## TECHNICAL MEMORANDUM

**PROJECT:** Salinas Valley Seawater Intrusion Model

**SUBJECT:** 2023 Model Updates to Address Groundwater Technical Advisory Comments

Figure 1. Mean Residual Water Level Bubble Plot within the 180-Foot Aquifer and Equivalent Areas

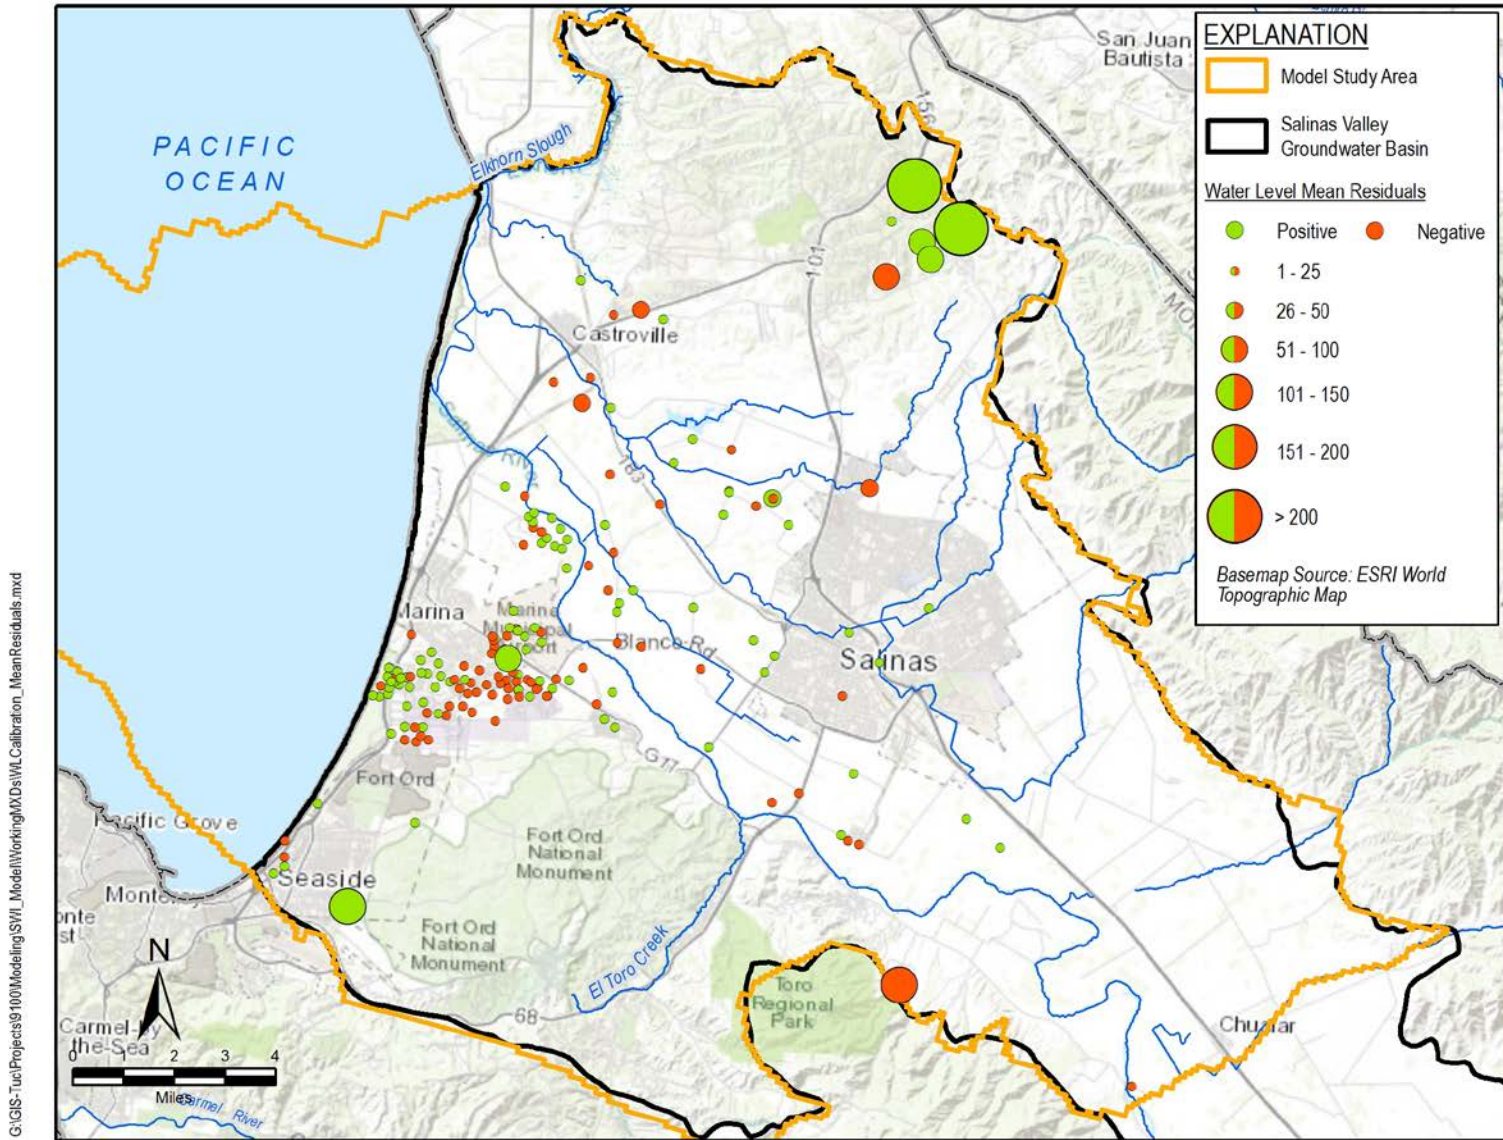
#### 1. Recommendation to improve model calibration of inland groundwater levels

While the seawater intrusion calibration provided a good match between simulated and observed intrusion, the GTAC suggested the groundwater level calibration be improved. Improvement to the groundwater level calibration without compromising the seawater intrusion calibration would strengthen the Model as a tool for project modeling.

Figure 1 and Figure 2 show the mean residual for each water level target in the model layers of the 180-Foot and 400-Foot Aquifers, respectively. Green bubbles indicate the mean residual for that location is positive and simulated water levels underestimate measured water levels. Orange bubbles indicate the mean residual for that location is negative and simulated water levels overestimate measured water levels. These figures show improvements to the model fit compared to Figures 4-5 and 4-6 in the earlier report.

The previously reported mean residual plots (Figures 4-5 and 4-6) indicated a simulated water level depression south and southwest of the City of Salinas that was greater than the observed water level depression in that area. The updated mean residual plots indicate that the simulated water levels closely correspond to the observed water levels near the City of Salinas and near the coast. There is not a strong spatial trend in the mean residuals in the 180-Foot Aquifer. In the 400-Foot Aquifer, there is a trend that the water levels are slightly too low to the south of the City of Salinas, and a little too high to the north and northwest of Salinas toward Castroville. The water level calibration in the 400-Foot Aquifer is better near the coast and in the seawater intruded area.

Figure 4. Simulated and Observed 500 mg/L Chloride Concentration Contours within the 180-Foot Aquifer in 1985, 1997, 2005, 2015, and 2020

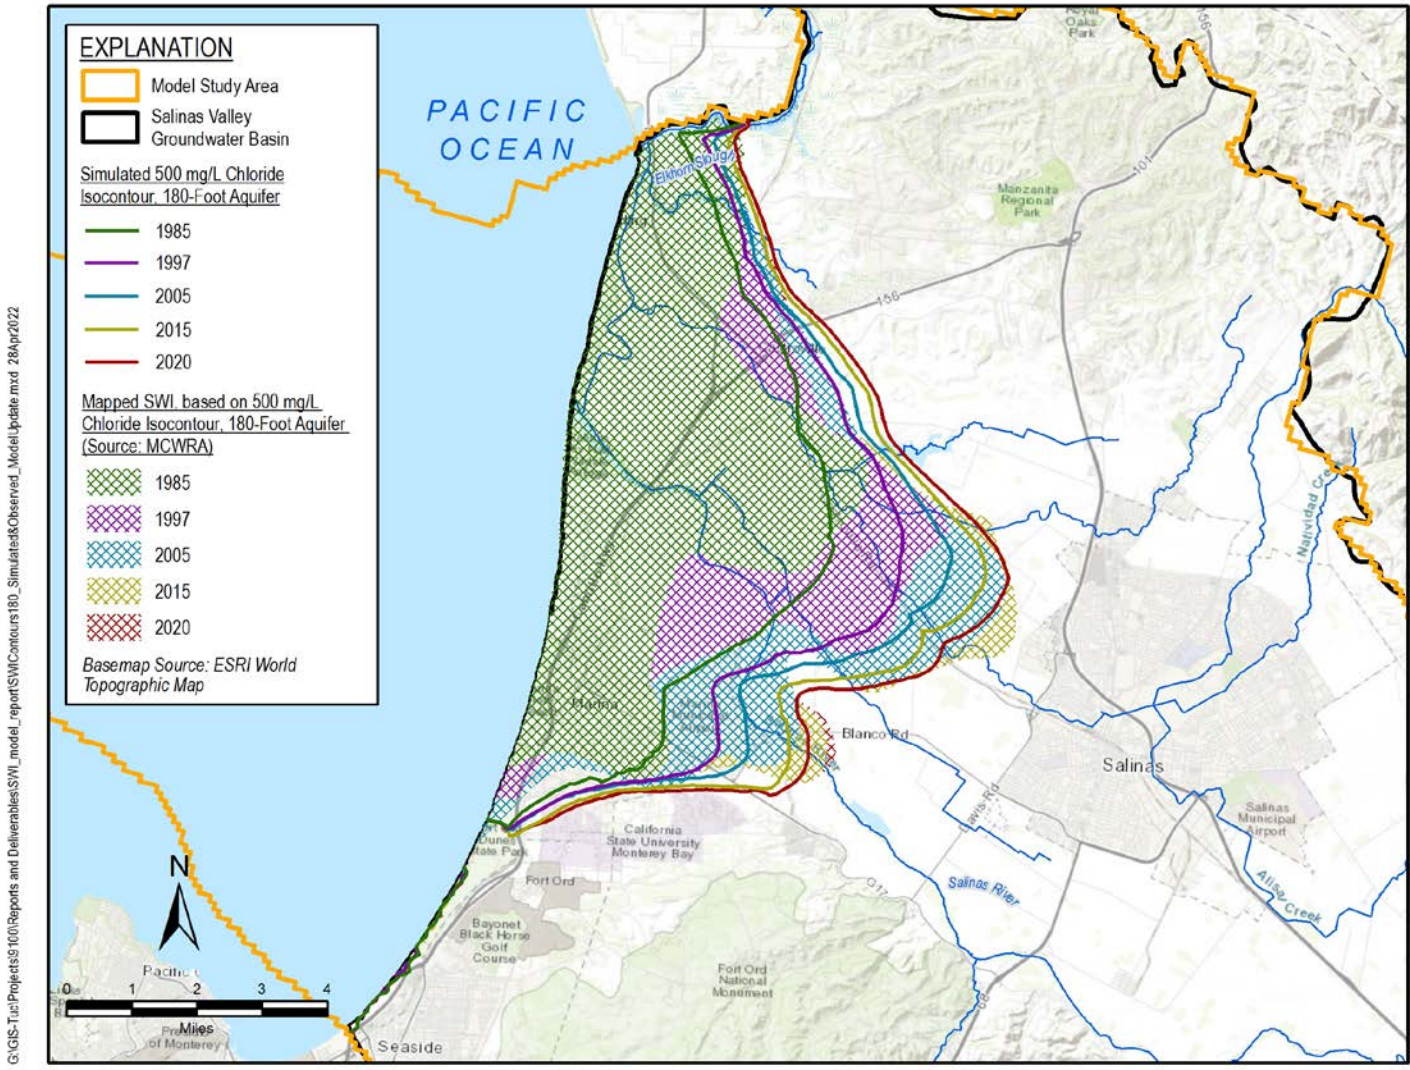
2. Address simulated chloride concentrations in the Seaside area of the model where not observed

The GTAC noted seawater intruding into the southwestern portion of the Model; however, intrusion hasn't been observed there before so it's unclear what conditions would allow for future seawater intrusion in that area. The GTAC recommended adjusting the calibration to reduce or eliminate simulated seawater intrusion in that area.

The updated model simulates the inland progression of seawater intrusion in the 180-Foot and 400-Foot Aquifers at similar but slightly slower rates than the previous model version. The simulated seawater intrusion in the updated model is closer to the observed in several areas. The extent of simulated seawater intrusion in the southern portion of the intruded area in the 180-Foot Aquifer matches the MCWRA observed contours, and also simulates the formation of the second, smaller seawater intrusion lobe near the Salinas River and Blanco Road. In the 400-Foot Aquifer, the updated model more accurately simulates the observed separation between the seawater intruding in from the coast and the saline “islands” that occur inland near Salinas. Though, between 2015 and 2020 the model simulates the connection of the saline island to the main plume. Additionally, seawater intrusion is not simulated in the Seaside area in the 180-Foot or 400-Foot Aquifers.

The model simulates a continuous inland progression of seawater intrusion since 1985. In the 180-Foot Aquifer, MCWRA observed no change in seawater intrusion in the southern lobe between 1985 and 1997, and no change in the main lobe between 2015 and 2020. The model simulated advancing seawater intrusion in these areas where it was not supported by the observed data. Additionally, MCWRA observed a significant increase in the intruded extent between the mid-1990s and 2005. The simulated seawater intrusion advanced at a slower rate than observed during that period; however, the final simulated extent of seawater intrusion in 2020 was similar to the MCWRA observed in both the 180-Foot and 400-Foot Aquifers.
